**SUSQUEHANNA STEAM ELECTRIC STATION
EMERGENCY PLAN REVISION 56
PLA-7279**

**Docket Nos. 50-387
and 50-388**

List of Changes Contained in
Revision 56 to SSES Emergency Plan

Emergency Plan Changes (Revision 55 to Revision 56)
(referenced page numbers are from Revision 55)

Page 1 INITIAL PAR ONLY

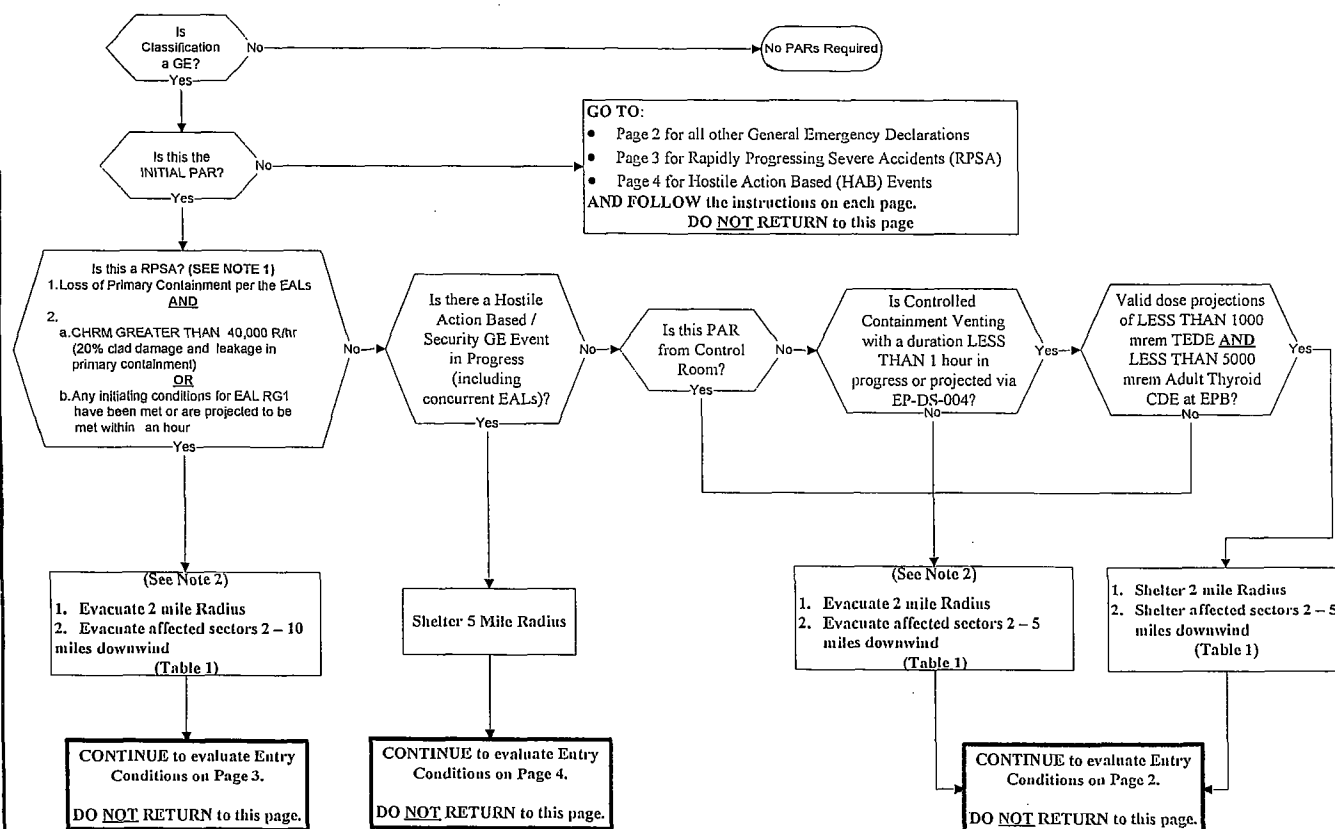
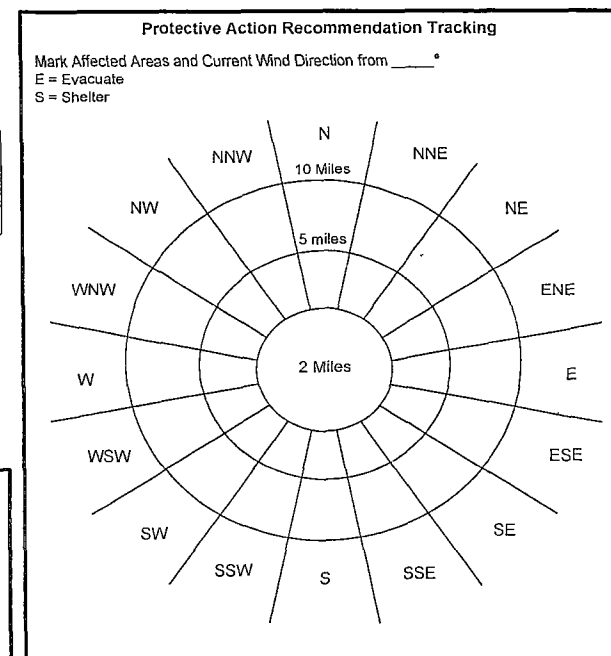
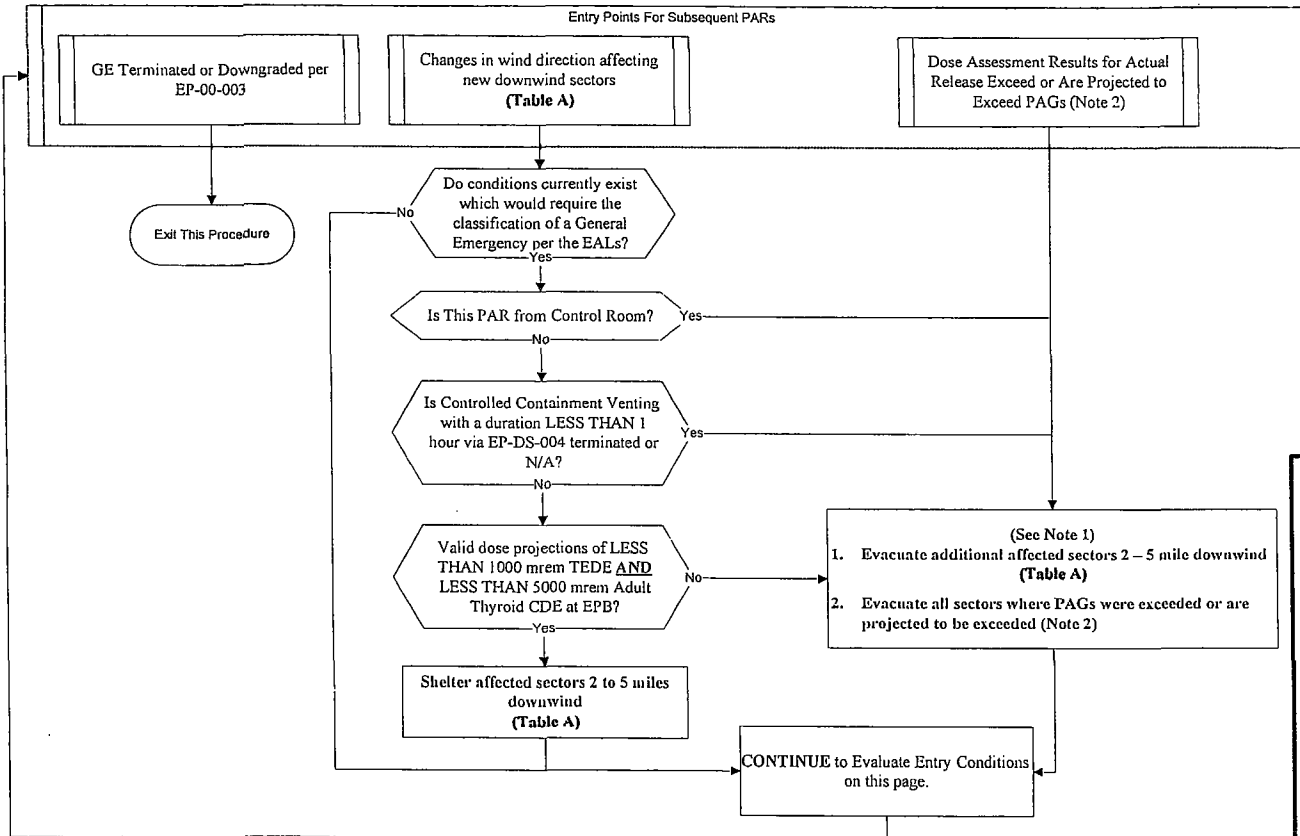
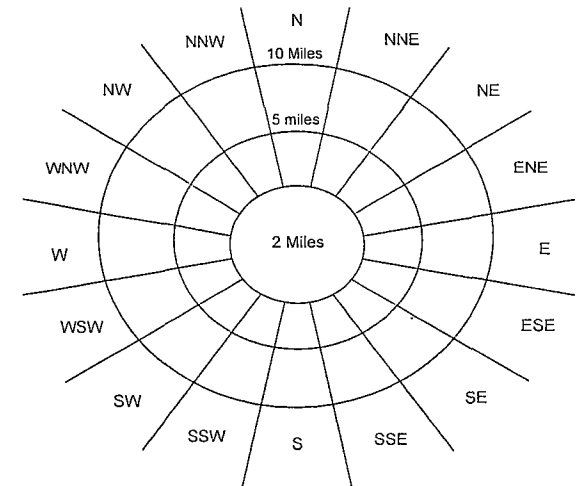
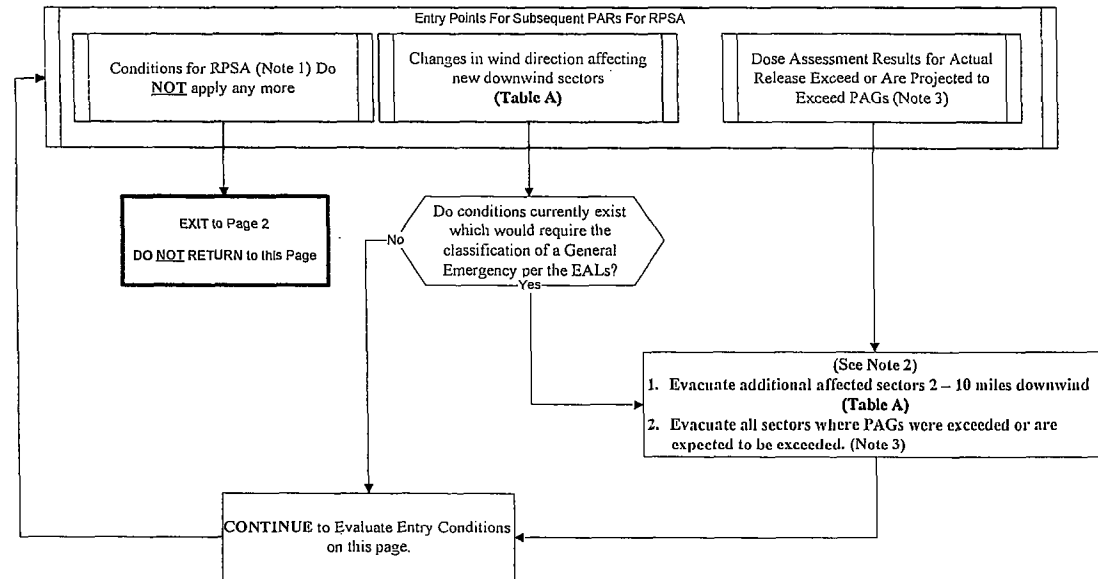
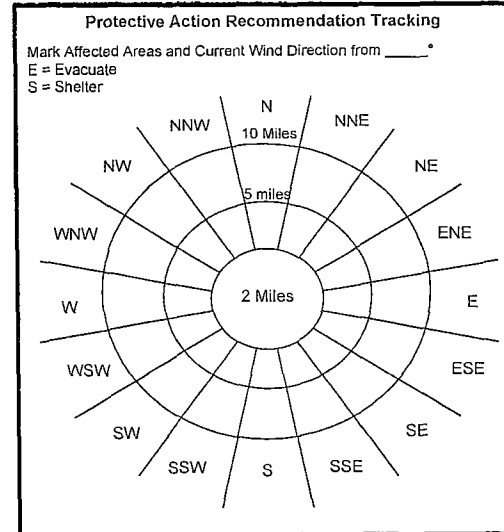
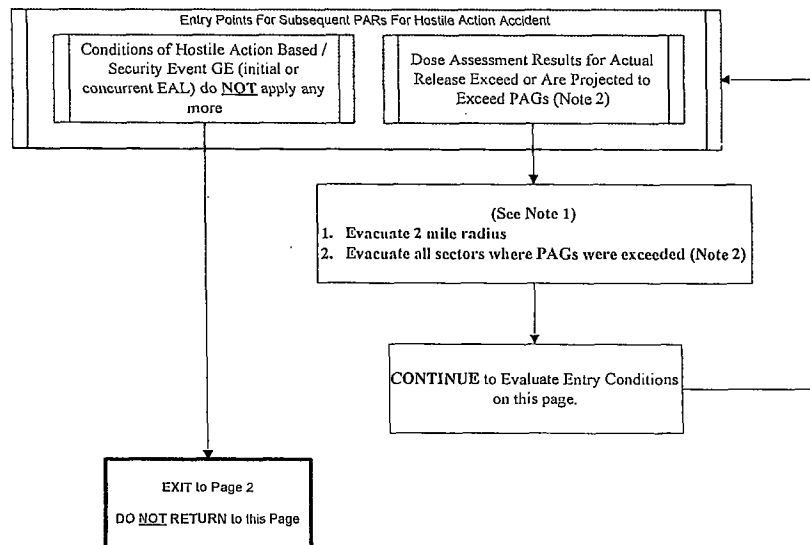
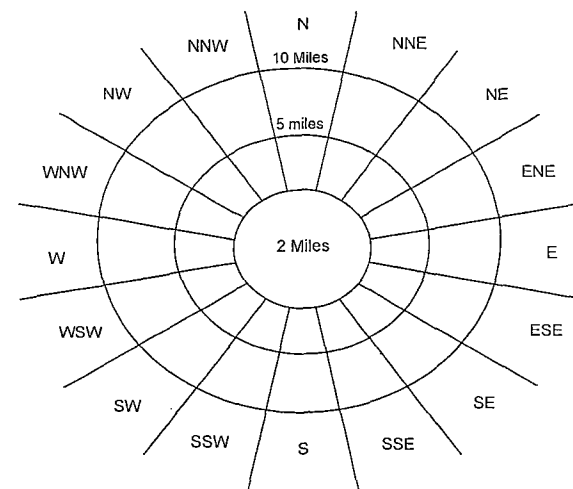
- 1) Change Revision 55 to 56 throughout the document.
- 2) Change Table 7.3 Protective Action Recommendations (Effective Pages 98-100) to align with NUREG-0654, Supplement 3, Rev 1. Specifics on what changed are described below:

SSES will provide an initial PAR to the Senior State Official within 15 minutes from the declaration of a General Emergency as follows:

1. For a Rapidly Progressing Severe Accident (RPSA):
 - a. Evacuate 2 mile radius;
 - b. Evacuate 2-10 miles downwind sectors.
2. For a Hostile Action Based (HAB) GE event:
 - a. Shelter 5 mile radius.
3. For all other General Emergencies:
 - a. Evacuate 2 mile radius;
 - b. Evacuate 2-5 miles downwind sectors.
 - 3.1 When there is a Controlled Containment Venting of less than an hour AND a valid dose assessment projects doses less than PAGs at EPB AND the PAR is issued by extended ERO (TSC or EOF):
 - a. Shelter 2 mile radius;
 - b. Shelter 2-5 miles downwind sectors.

Initial PAR shall also advise citizens to take KI in accordance with the state's emergency plans and advise remainder of the EPZ to monitor and prepare.

Continue assessment based on available plant and field monitoring information and evaluate for subsequent PARs in accordance with:

1. Until RPSA conditions do not apply any more, ERO shall consider the following subsequent PARs based on dose assessment results or changes in wind direction affecting new sectors, if conditions exist which would require classification of a General Emergency per EALs:
 - a. Evacuate additional affected sectors 2-10 miles downwind
 - b. Evacuate all sectors where PAGs were exceeded.

2. Until HAB conditions do not apply any more, ERO shall consider the following subsequent PARs based on dose assessment results:
 - a. Evacuate 2 mile radius
 - b. Evacuate all sectors where PAGs were exceeded.
